**ADDITIONAL NOTICE**

**DATE:** August 12, 2022  
**TO:** Blue Bird Owners  
**Subject:** RECALL R19AI – Service Brake Switch Bracket Deformation on Driver Control Module

**SUBJECT: RECALL R19AI – Service Brake Switch Bracket Deformation on Driver Control Module**

## R19AI – Ford Service Brake Switch Bracket Deformation

Figure 1

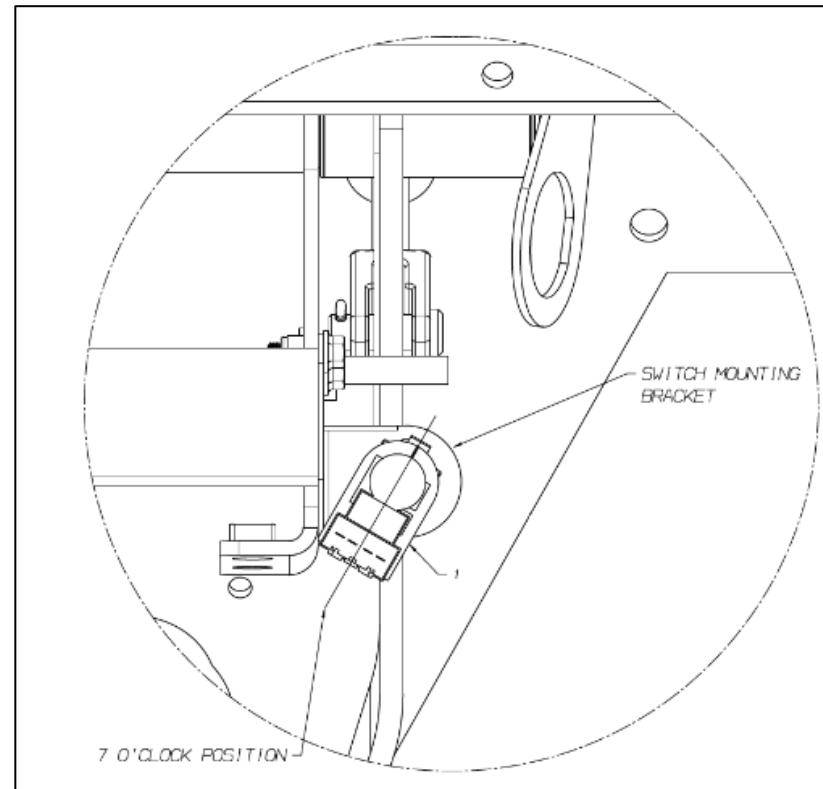
1. Locate service brake switch in front of driver's area, above brake pedal arm.
2. Disconnect the electrical connector from the service brake switch.
3. Rotate the service brake switch clockwise to the 7 o'clock position, and remove. (Figure 1)  
*The switch will not be reused, it should be marked as bad and discarded.*

Figure 2

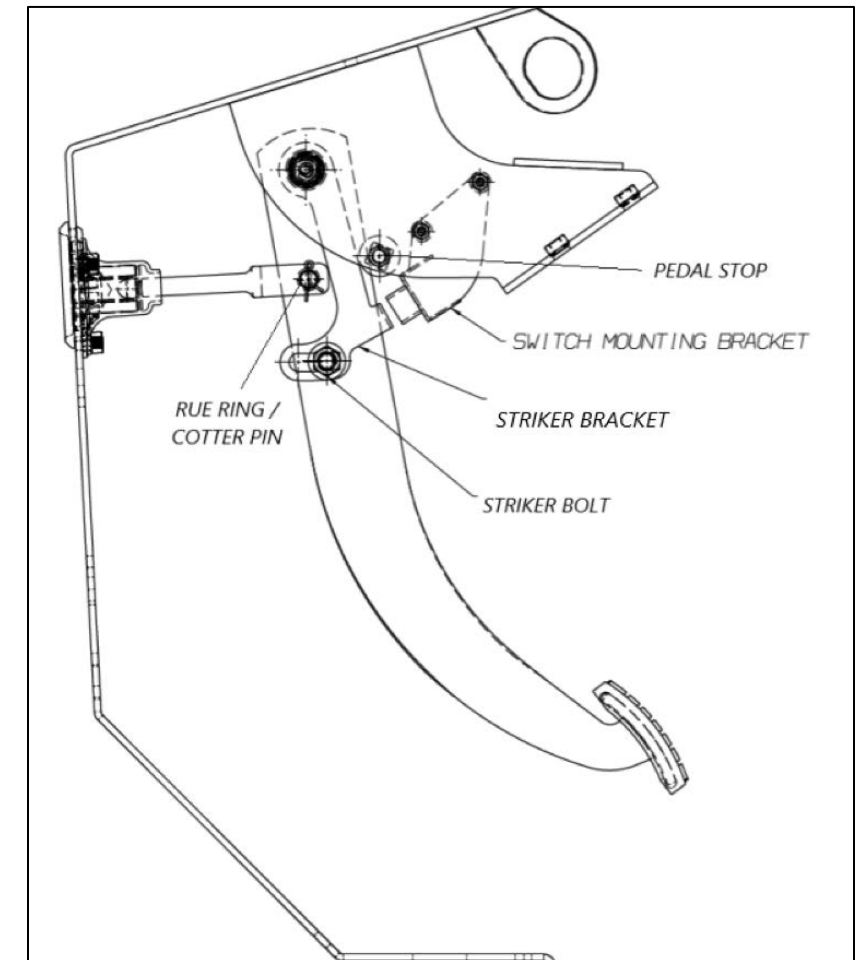
4. Remove the two fasteners mounting the switch mounting bracket to the steering column housing. Retain the mounting fasteners. *The switch bracket will not be reused, it should be discarded.* (Figure 2 and 3)

5. Remove and retain the E-Clip, nut and washer from brake pedal pivot shaft (Figure 3)
6. Remove the rue ring (or cotter key) and clevis pin from yoke/brake pedal (Figure 2)

7. If necessary, back off the pedal stop (threaded bolt) from steering column bracket to allow free motion of the brake pedal. (Figure 2)
8. Rotate brake pedal fore and aft, as necessary, while sliding to the right until removed from pivot shaft. (Figure 3)

Figure 3

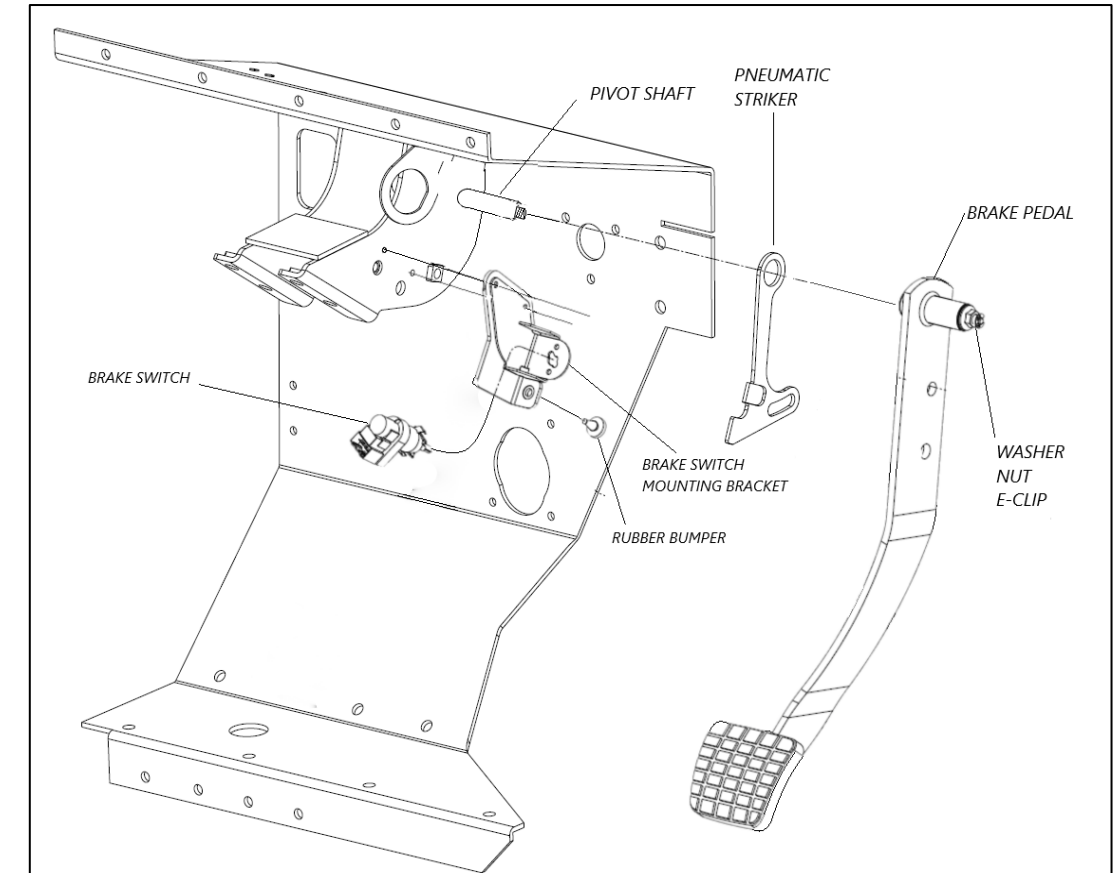
9. Remove striker bracket from brake pedal assembly. (Figure 3) Retain the 1/2" striker nut, bolt and washers, as they will be reused.  
*The striker bracket will not be reused, it should be discarded.*
